Work Order ID 165176

Item ID: 647.0116 Accept *N900040100* Setup Start *NS1*
Revision ID: Stop *NS2*
Item Name: Doubler
Start Date: 8/22/2017 Start Qty: 6.00 *6* Cust Item ID:
Required Date: 9/13/2017 Req'd Qty: 6.00 *6* Customer:

APICAL INDUSTRIES, INC.	ENGINEERING CHANGE NOTICE NO. 03985			SHEET 1 OF 2	
	DWG NO. 647.0100	REV: A	PREPARED BY J. BECKER	DATE: 7/15/13	EFFECT ON DWG ☐ INC. ☒ UNINC.
	DWG TITLE: SHEET METAL				
	APPROVED BY: ENGR. 	MFG 	QC 	EFF. NEXT ORDER	
TRANSACTION CODES (TC): A-ADD R-REVISE C-CREATE D-DELETE	REASON: REVISED NOTE 2. ADDED 647.0117

SHEET 1, ZONE D1 IS:

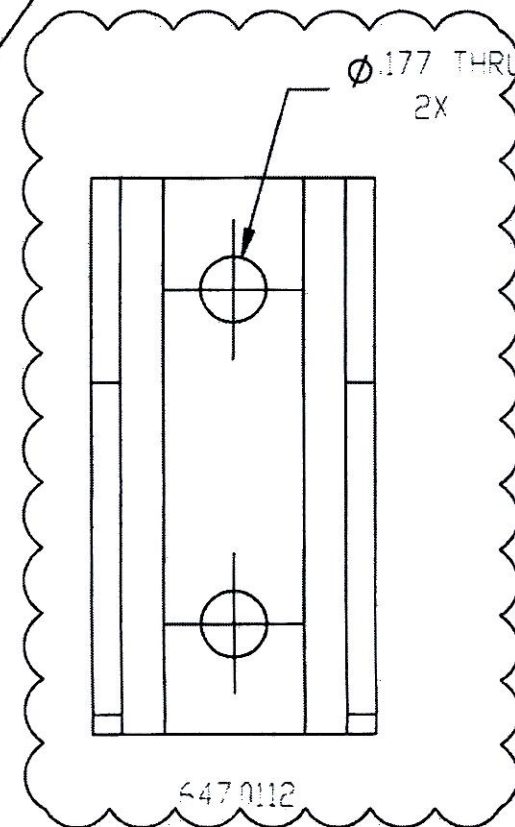
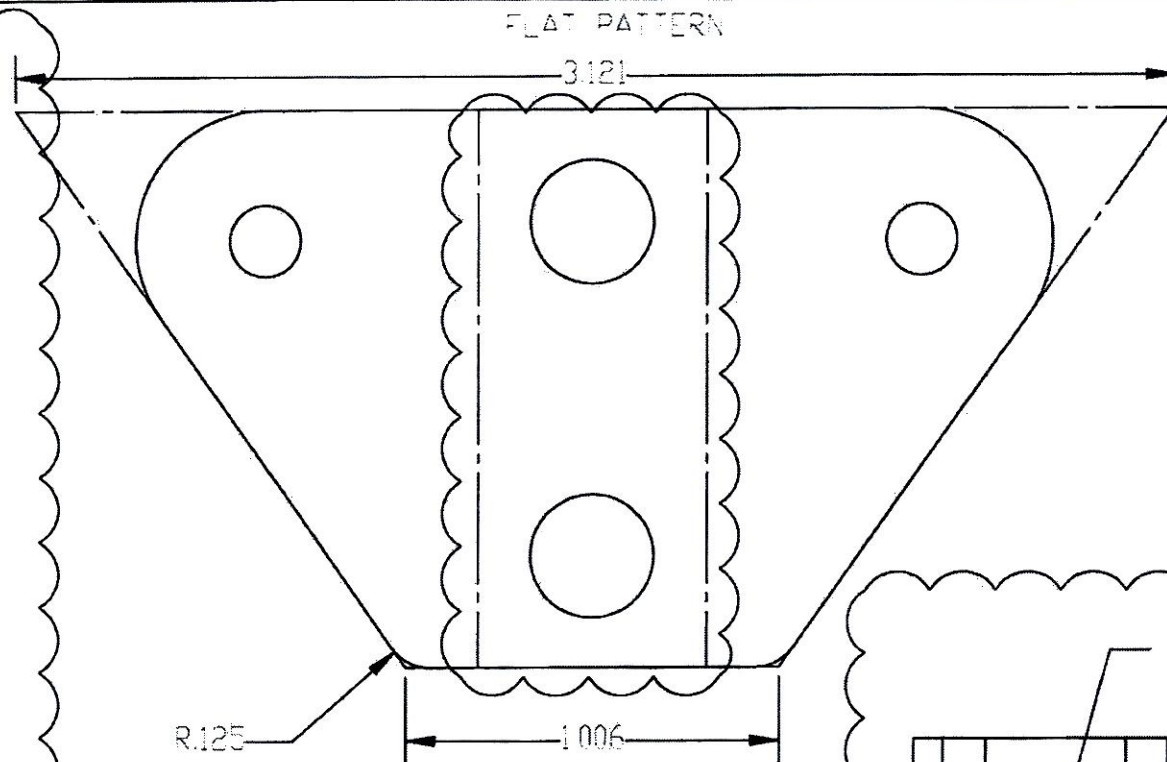
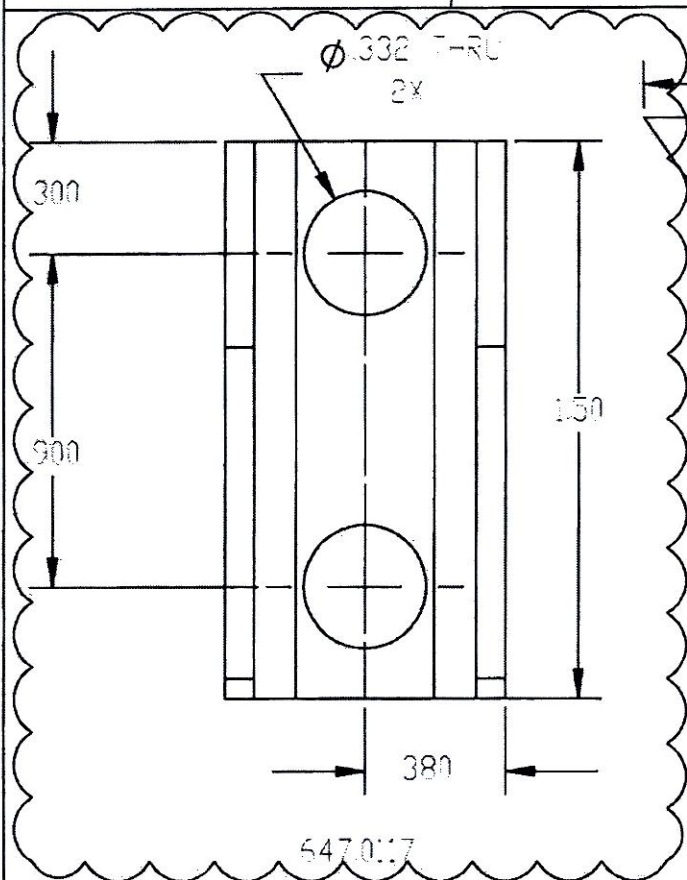
- 1 MATERIAL: ALUMINUM 2024-T3 PER AMS-QQ-A-250/4.
- 2 FINISH: IAW MPP-172 ANODIZE IAW SECTION 2.1, PRETREATMENT IAW SECTION 3.1 AND PRIMER IAW SECTION 4.1.
- 3. DEBURR AND BREAK ALL SHARP EDGES.
- 4. IDENTIFY IAW MPP-120.
- 5 MATERIAL: 304 SS IAW AMS 5643.
- 6 FINISH: PRIME IAW MIL-P-23377J TYPE I CLASS N.
- 7 OTHER DIMENSIONS SAME AS 647.0112.

C	647.0117	STRUT BRACKET		△	△
F/NTC	PART NUMBER	DESCRIPTION		MATERIAL	SPECIFICATION
DOCUMENTS EFFECTED: ☐ MDL ☐ INSTALL INSTRUCTIONS ☐ ICA ☐ FMS ☐ BOM				CHANGE CATEGORY ☐ MAJOR ☒ MINOR	DER REVIEW REQUIRED ☐ YES ☒ NO
